Park Avenue Housing

Tucson, Arizona

25 JUNE 2014
DRC: MTG

"AS PERMITTED" - JULY 11, 2013 PERMIT SET

BUILDING AXON 01
SCALE 01

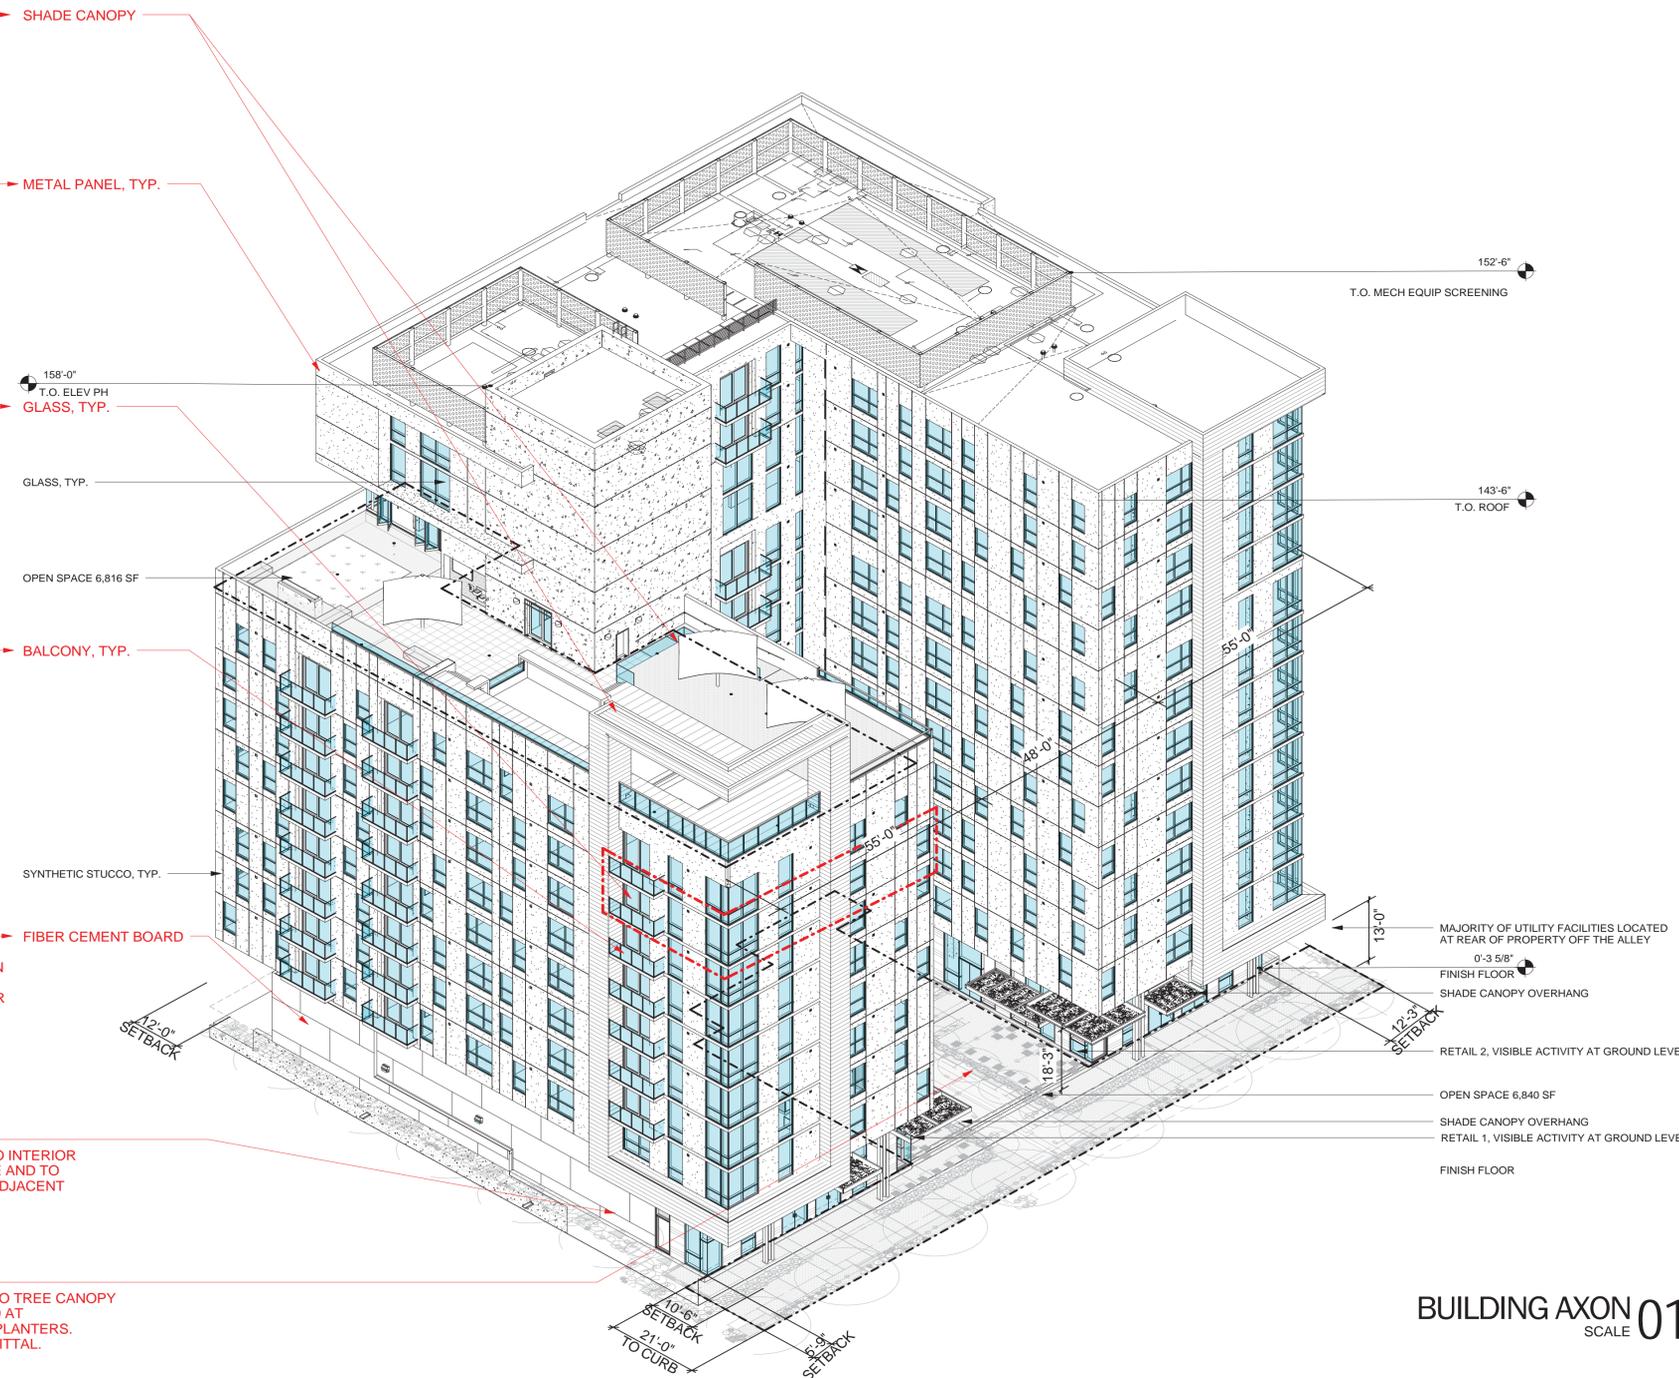
1 SHADE CANOPY REVISION
 • ICONIC SHADE CANOPY REVISED AT AMENITY DECK TO COMPLEMENT ADDED SHADE STRUCTURES.

2 MATERIAL REVISION
 • HORIZONTAL VOLUME ON LEVEL 12 AND LEVEL 13 HAS BEEN REVISED FROM THE PROPOSED METAL PANEL TO EIFS TO COORDINATE WITH THE COMPOSITION OF THE CORNERS ON PARK AVE. METAL PANEL RELOCATED TO PARK AVE ELEVATION.

3 GLAZING REVISION
 • GLAZING WAS REVISED TO PROVIDE A MORE ENERGY EFFICIENT FAÇADE THAT WAS ACCEPTABLE TO THE 2012 INTERNATIONAL ENERGY CONSERVATION CODE (IECC) AND CITY OF TUCSON COM-CHECK. REFER TO GLAZING STUDY.

4 BALCONY REVISION
 • BALCONY LOCATIONS REVISED FROM PARK AVE (EAST ELEVATION) TO NORTH, SOUTH, AND WEST ELEVATIONS WITH ADDITIONAL UPDATES IN COURTYARD TO CONTROL ACTIVITY CONCERNS EXPRESSED IN DRC REVIEW. LEVEL 12 AND LEVEL 13 NORTH EAST BALCONIES (2 TOTAL) HAVE BEEN REVISED FROM FULL DEPTH TO A REDUCED JULIET BALCONY. REFER TO IMAGES ON PAGE 3 OF 3 FOR LOCATION.

5 MATERIAL REVISION
 • ON THE NORTH, WEST, AND SOUTH FAÇADES THE LEVEL 1 WALL HAS BEEN REVISED FROM BOARD FORMED CONCRETE WALL TO A COLORED FIBER CEMENT BOARD PANEL TO PROVIDE A MORE FRIENDLY MATERIAL AT PEDESTRIAN LEVEL.

6 GLAZING REVISION
 • STOREFRONT GLAZING RELOCATED TO INTERIOR COURTYARD TO ACTIVE PUBLIC SPACE AND TO PROVIDE VISUAL SEPARATION FROM ADJACENT PARKING LOT FOR RETAIL TENANT.

7 LANDSCAPE REVISION
 • OVERHEAD SHADE TRELLIS REVISED TO TREE CANOPY WITH LANDSCAPE LIGHTING PROVIDED AT PEDESTRIAN LEVEL IN BENCHES AND PLANTERS. REFER TO REVISED LANDSCAPE SUBMITTAL.

REFER TO OUTLINE ON AXON AT PARK AVE FAÇADE FOR REVISED GLAZING LOCATIONS AND PERCENTAGES DESCRIBED BELOW.

ORIGINAL DESIGN	UPDATED DESIGN
GLAZING SYSTEM: 56%	GLAZING SYSTEM: 46%
WALL SYSTEM: 44%	WALL SYSTEM: 54%

GLAZING WAS REVISED FROM 56% TO 46% PROVIDING A TOTAL DELTA OF 10% REVISION TO COMPLY WITH ENERGY EFFICIENCY REQUIRED PER 2012 IECC.

**DEVELOPMENT PACKAGE
HARDSCAPE PLAN**

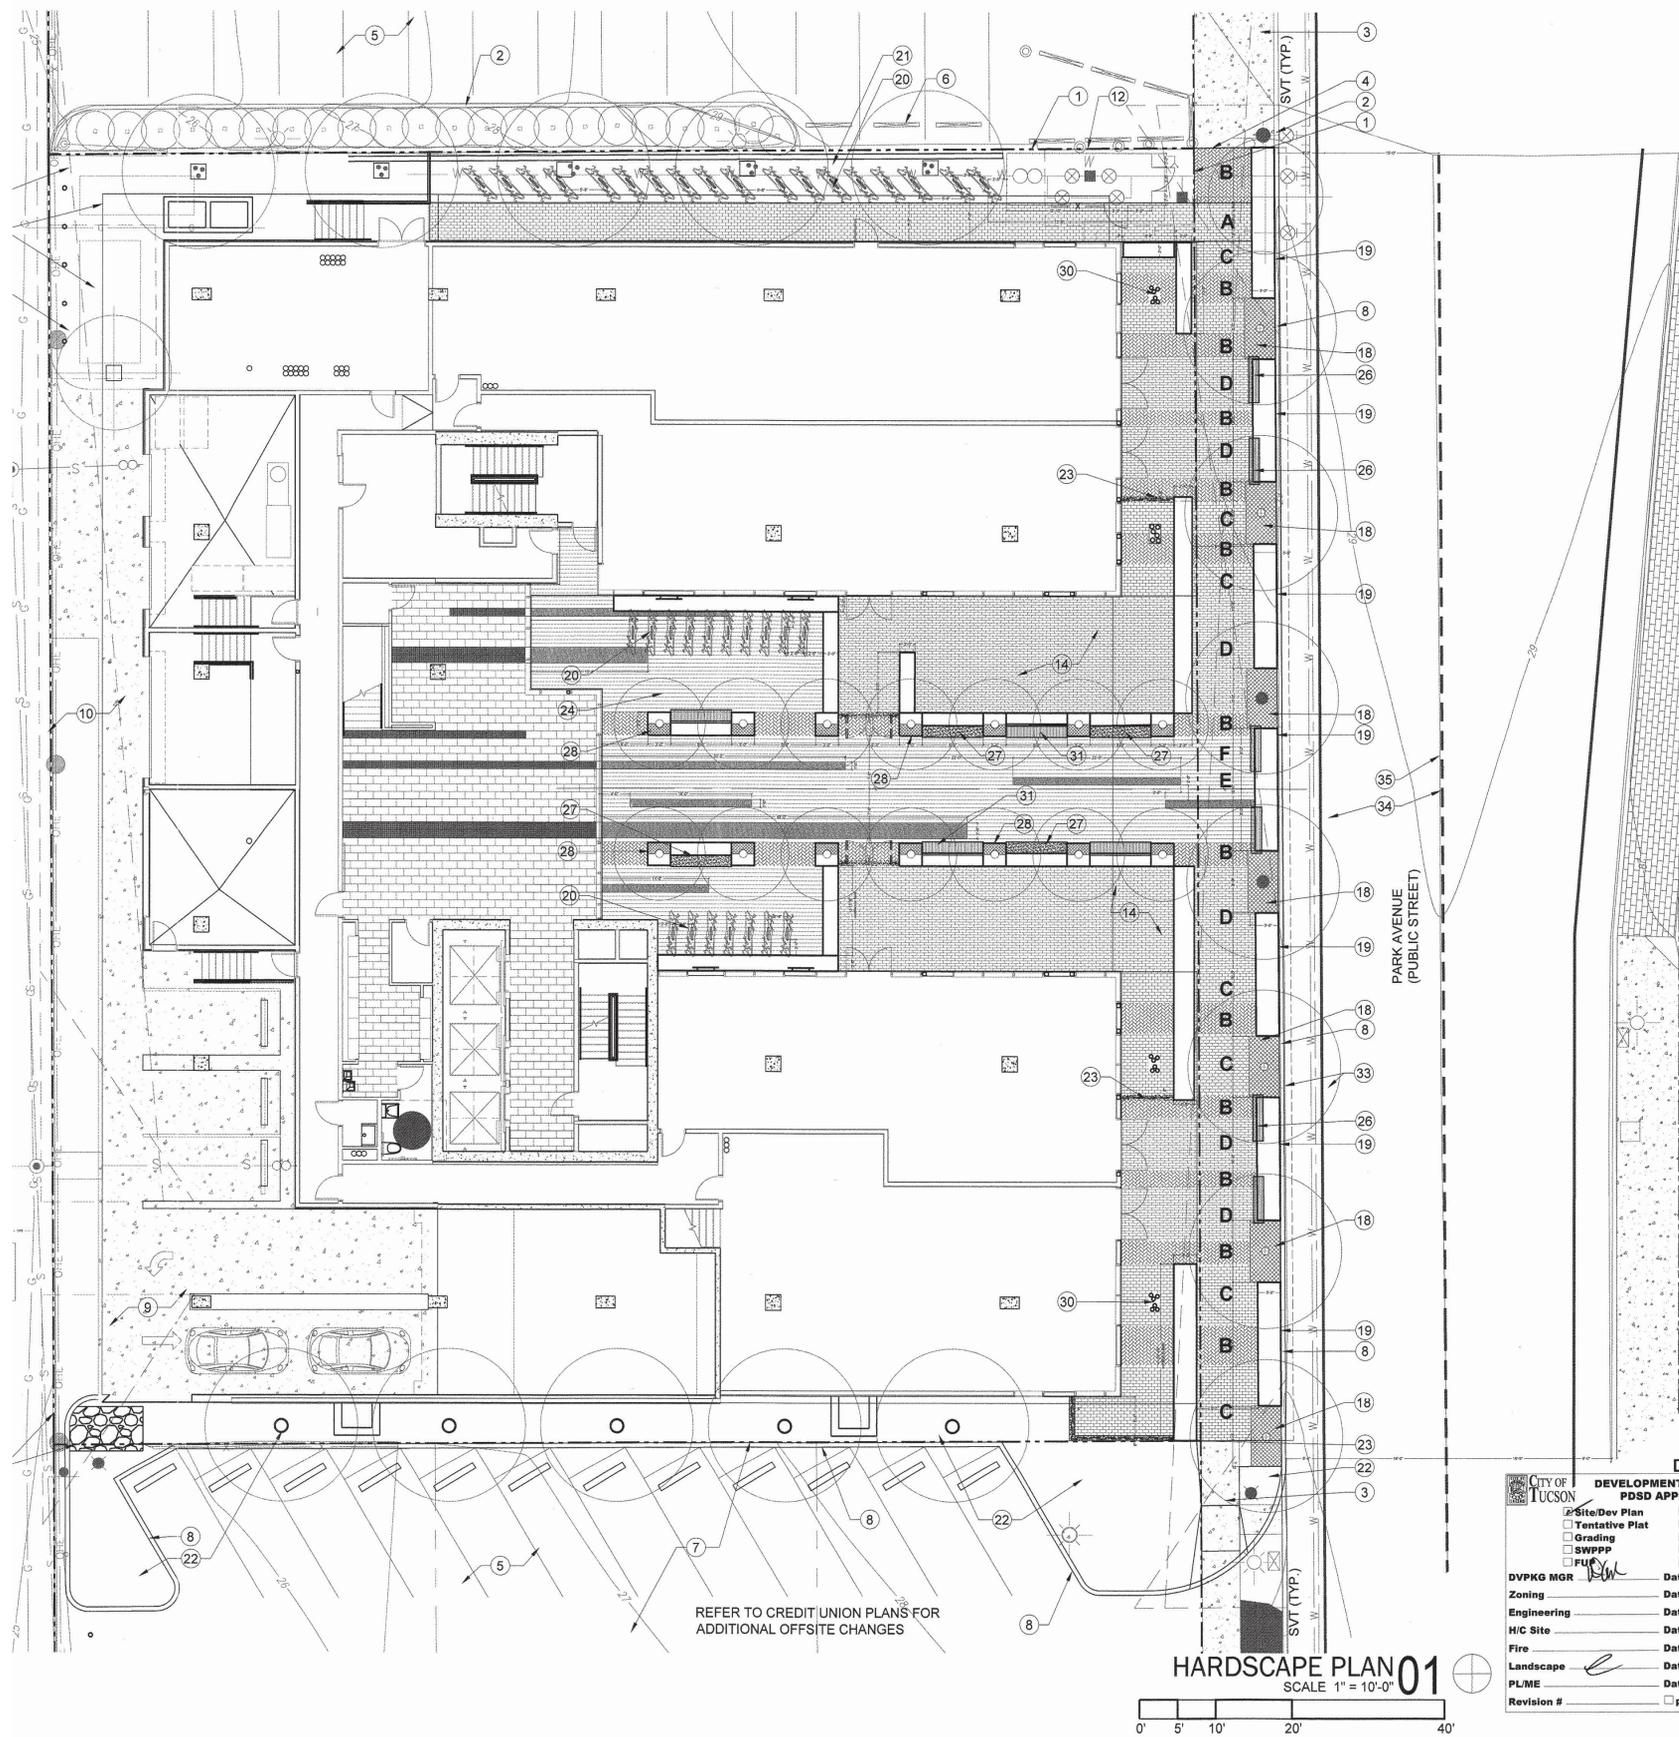
2 PLANT MATERIAL

- PER UOD REQUEST ADJUSTED PLANT MATERIAL TO DETER PEDESTRIAN J-WALKING
- PER UOD REQUEST REVISED PLANT SELECTIONS TO UTILIZE LOW WATER USE SUCCULENTS
- PER UOD REQUEST REVISED PLANT SELECTIONS TO USE SUCCULENTS THAT HAVE FEWER SHARP SPINES
- PER UOD REQUEST PLANT MATERIALS SHALL BE MAINTAINED AT 30" MAXIMUM HEIGHT

3 PLANTER PLACEMENT

- PER THE REQUEST OF THE UOD DESIGN COMMITTEE, MOVED PLANTERS ADJACENT TO VERTICAL CURB TO DISCOURAGE PEDESTRIAN TRAFFIC FROM CROSSING FROM THE DEVELOPMENT

- REVISED THE PAVER DETAILS TO UTILIZE STANDARD SPECIFICATION REQUIREMENT 932 WITH COMPACTED AGGREGATE BASE
